# INDIANA DEPARTMENT OF TRANSPORTATION

# AGENDA

## December 18, 2024, Standards Committee Meeting

RE: Agenda for the December 18, 2024, Standards Committee Meeting

<b>INDIANA DEPARTMENT OF TRANSPORTATION</b>	
<b>FABRICATION TOLERANCES, INDEX, AND GENERAL NOTES</b>	
SEPTEMBER 2022	
STANDARD DRAWING NO.	E 707-BPBF-01
	 06/15/2022 DESIGN STANDARDS ENGINEER DATE
	 06/27/2022 CHIEF ENGINEER DATE

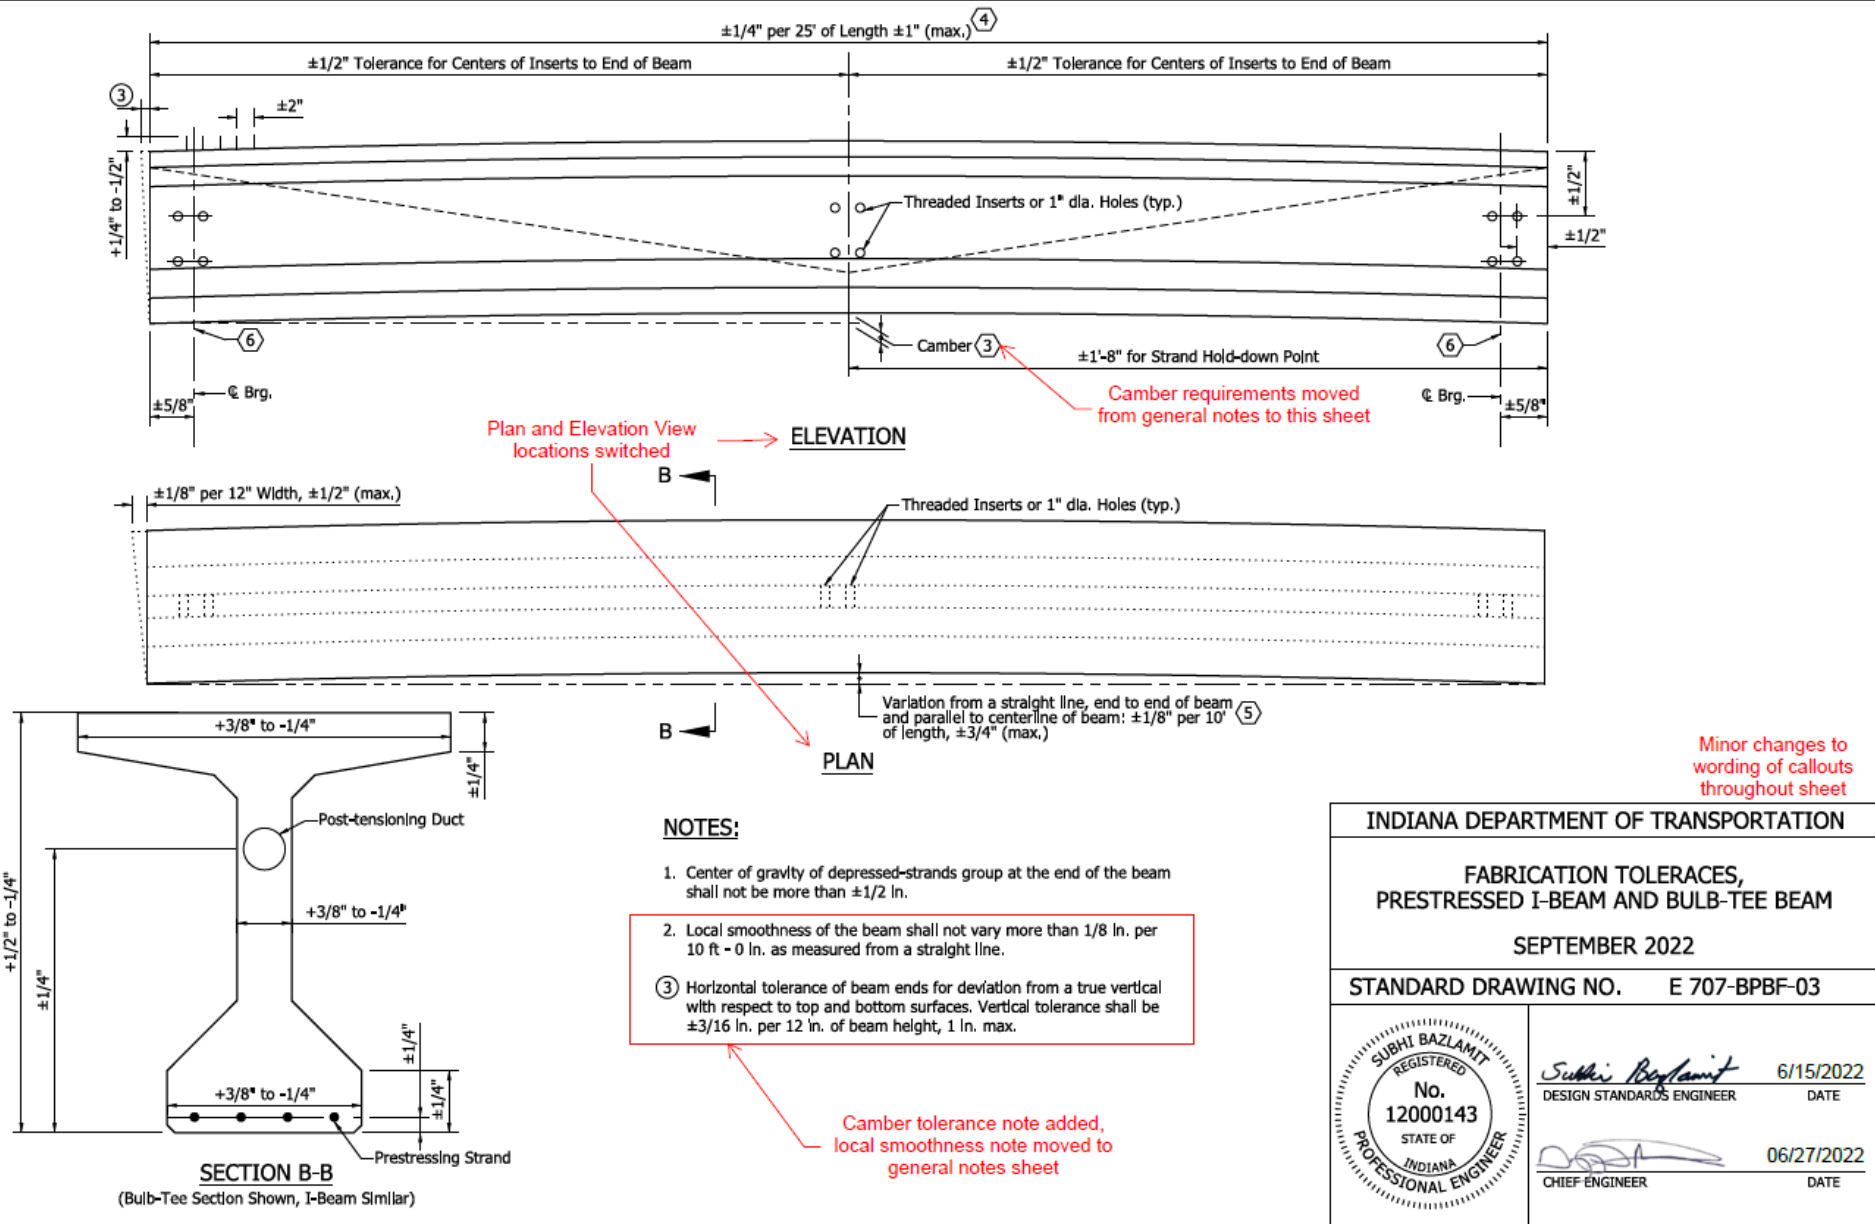
Symbols removed from general notes sheet.

Beam-specific tolerance notes moved to the applicable sheets

Local smoothness requirement moved from individual sheets to this sheet.
